SERVICE BULLETIN

SB No. 015 Issue No. 1

TITLE	RUDDER PEDAL TO SIDEWALL AND RUDDER CABLE CLEARANCES
CLASSIFICATION	This Service Bulletin has been classified as mandatory by the CAA
COMPLIANCE	(a) Before further flight) after receipt (b) Within 50 flying hours) of this Bulletin

RUDDER PEDAL TO SIDEWALL AND RUDDER CABLE CLEARANCES

FIGURE 1

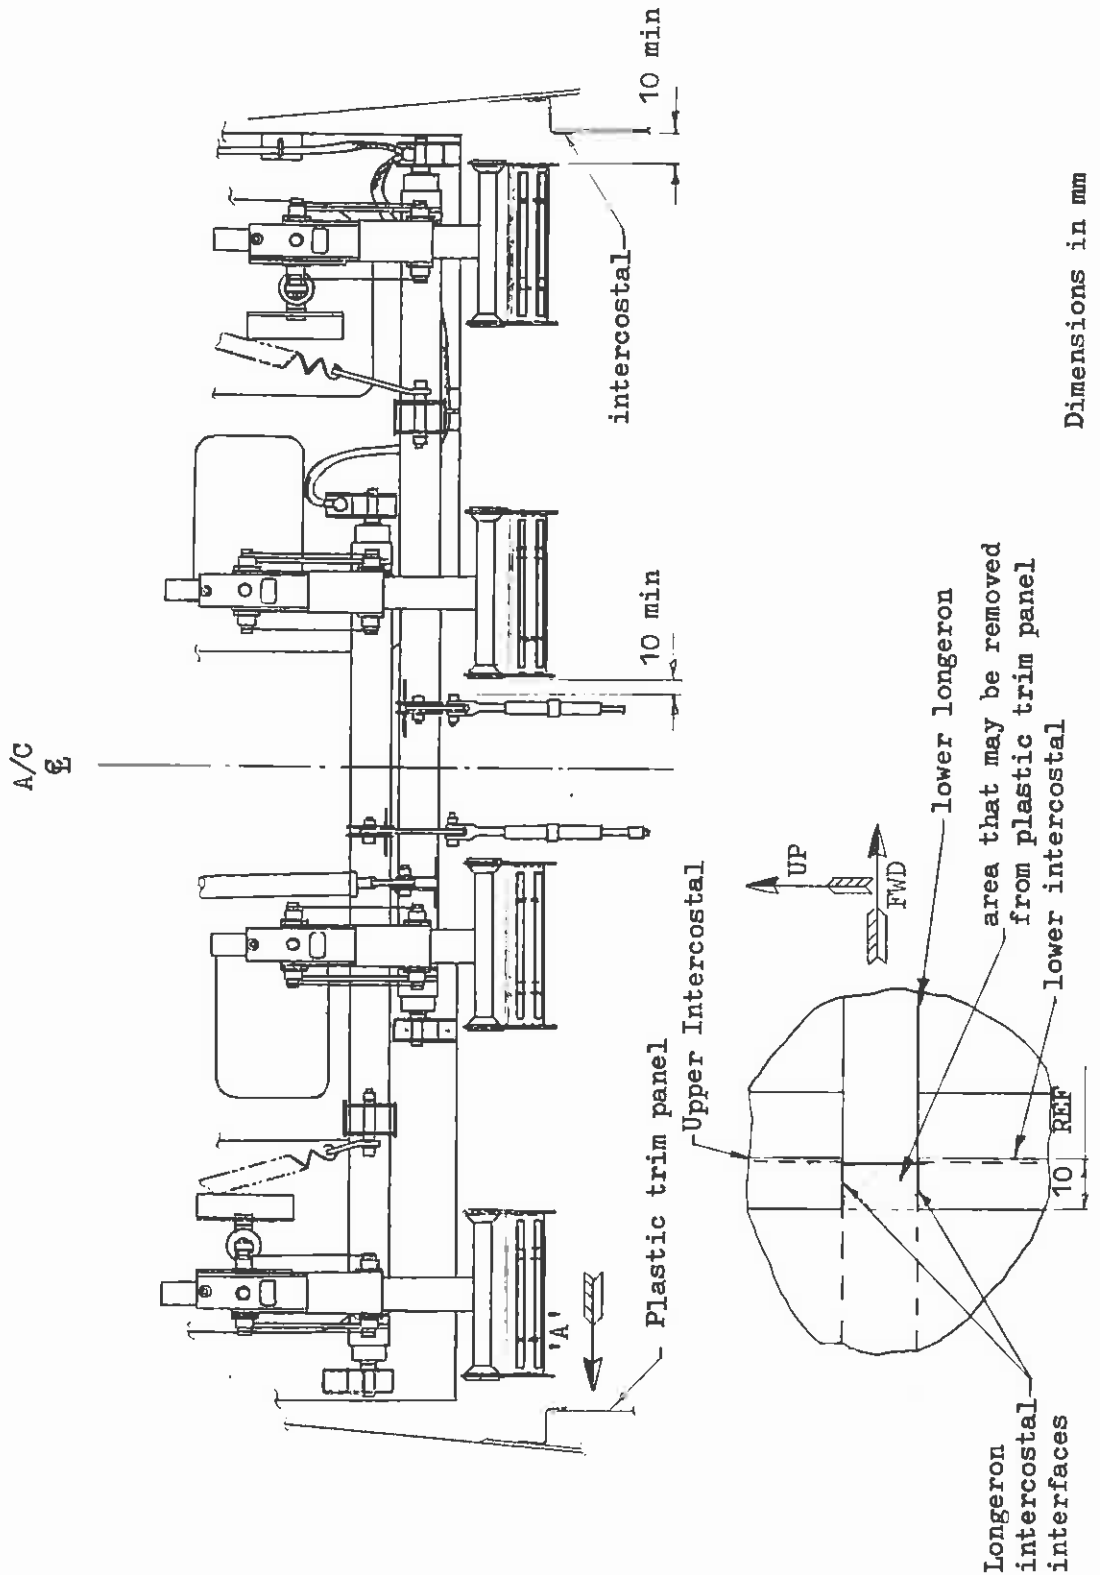
3.1 Inspection (Ref. Fig. 1, page 3).

Check the minimum rudder pedal to intercostal clearance and the minimum rudder pedal to rudder cable turnbuckle bolt clearance in any configuration port and starboard, with a light sideways force on the pedals (aprox. 10 lbf or 4.53 kg) applied in a direction to minimise the gaps.

If the smallest clearance found is:

- a) More than 10mm proceed to para 3.2.
- b) Between 5mm and 10mm the aircraft is to be placarded "No Aerobatics", and the aircraft may not be used for aerobatics or spinning until Mod M232 "Introduction of Rudder Pedal Packing for Increased Clearance of Surrounding Components" is incorporated at the next 50 hour check. See para 3.2.
- c) Less than 5mm Mod M232 is to be incorporated before further flight (excluding any necessary positioning flights for incorporation of the mod). See also Para 3.2.

3.2 Inspection (Ref. Fig. 1 Page 3)

3.2.1 Check that the plastic trim panel is under intercostal ideally by 10mm, ref. view on Arrow 'A' Fig.1.

3.2.2 Check for distortion in plastic trim panel.

3.3 Rectification with reference to paragraph 3.2.

3.3.1 If plastic trim panel is not under intercostal place it under. If difficulty is encountered whilst attempting to replace plastic trim panel the following solutions are recommended:

(i) Remove excess Redux etc at intercostal/longeron interface. Do not damage items.

(ii) Apply hot air to plastic trim panel and push into position.

(iii) Cut a small notch in plastic trim panel the width of longeron and intercostal, apply hot air to fit into position.

3.3.2 Apply hot air to plastic trim panel to restore it to its original shape. Continue as paragraph 3.3.1 if required.
